ARA/Apparel Export Co. Ltd. (10716)

20.MARCH.2014

Identified Priority 1 Concerns

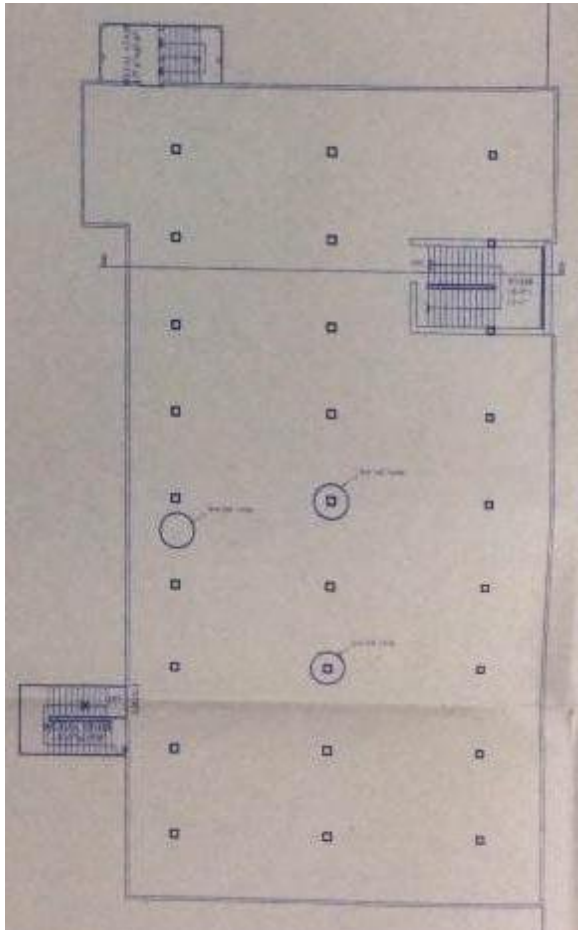
Priority 1 Concern

Empty area for 4th and 5th floor.

- **NOTE:** The adequacy of column and foundation capacity are required to investigate further and must be kept empty until a Detailed Engineering Assessment is carried out and any remedial measures resulting are completed.

Column on ground floor.

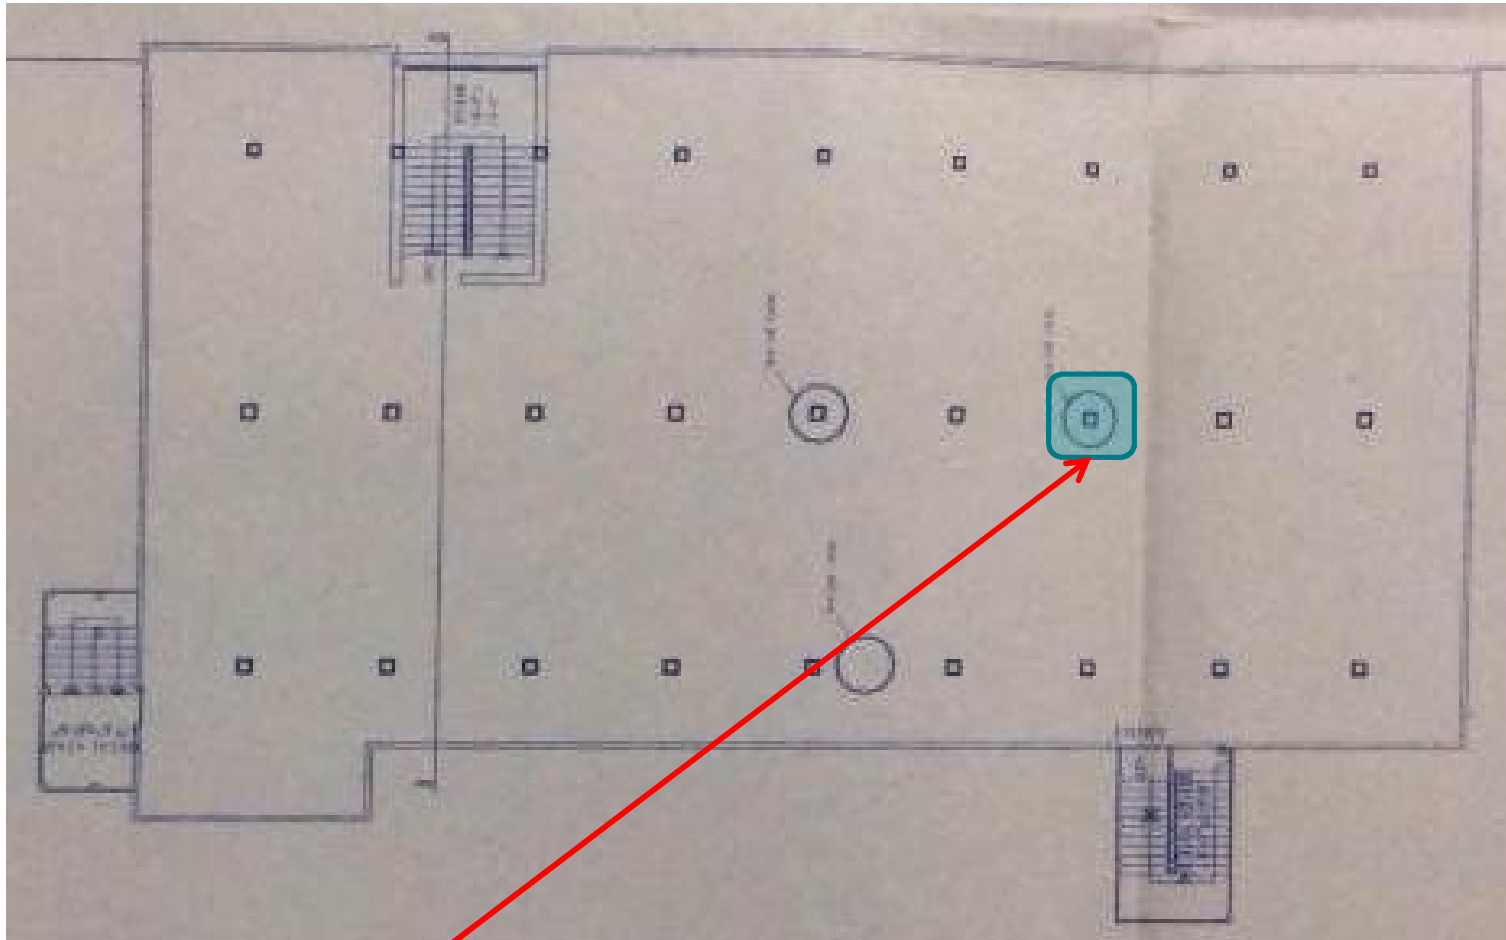
Key Column Check for Building 1:

Load rundown at the key steel column, it is found that the column is within the range of FOS less than 1.25 which is **RED** rating.

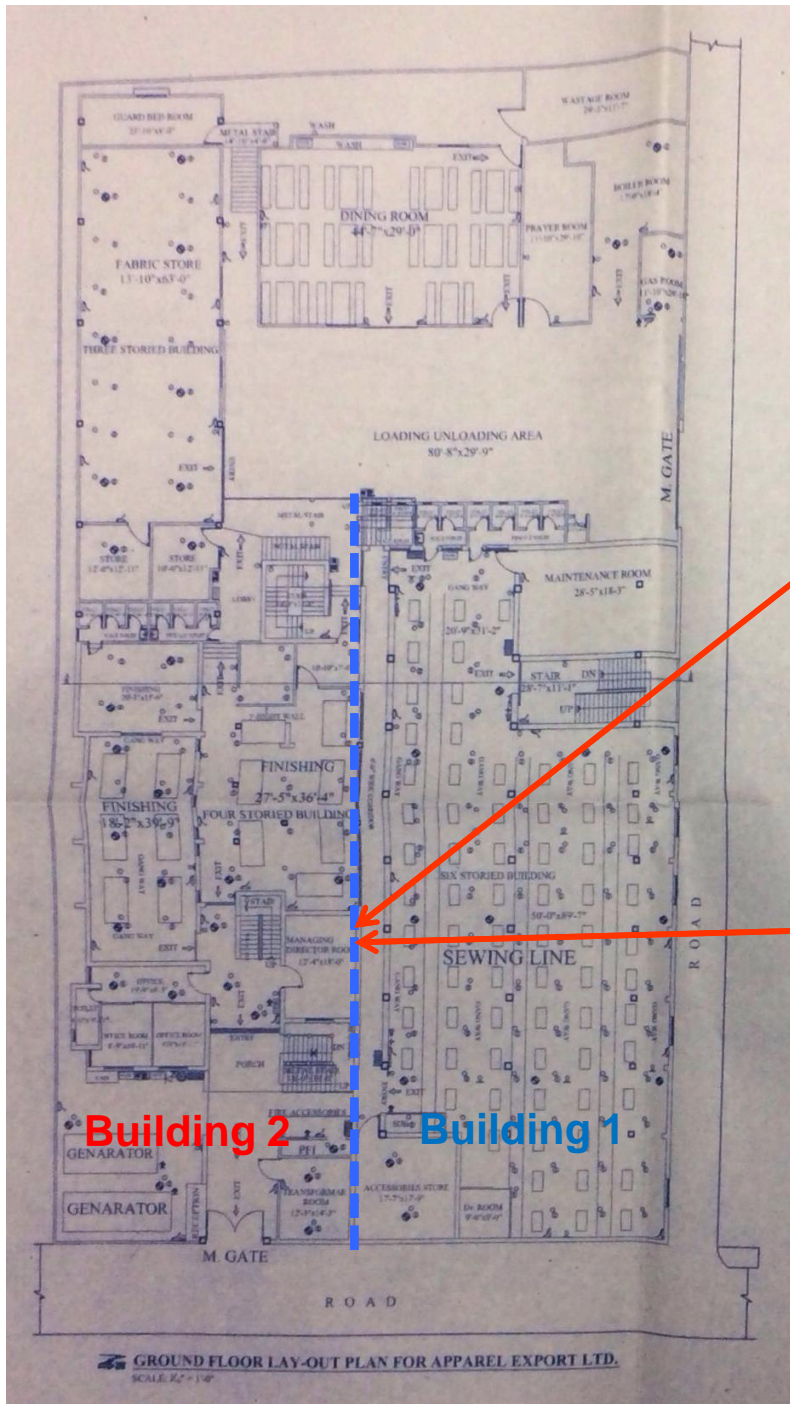
No movement joint properly established
to separate Building 1 and Building 2

Priority 1 Concern

This beam appeared to be supported by column from building 1

No movement joint established properly to separate building 1 and 2. Building assessment including column and foundation capacity check are required.

----- Movement joint to be established properly

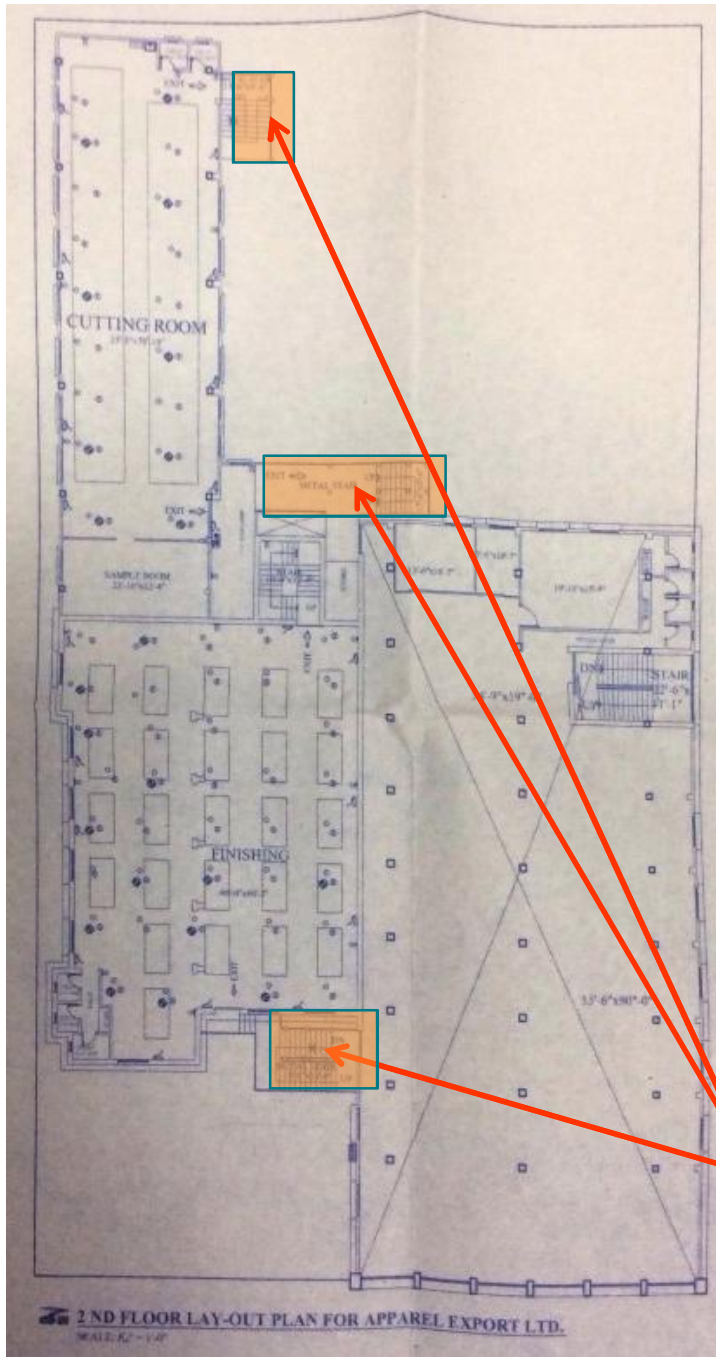
Building 3:

Priority 2 Concern

Uncontrolled heavy storage on ground floor.
Reduce stacking height of storage to ensure
total load does not exceed 3.0kPa
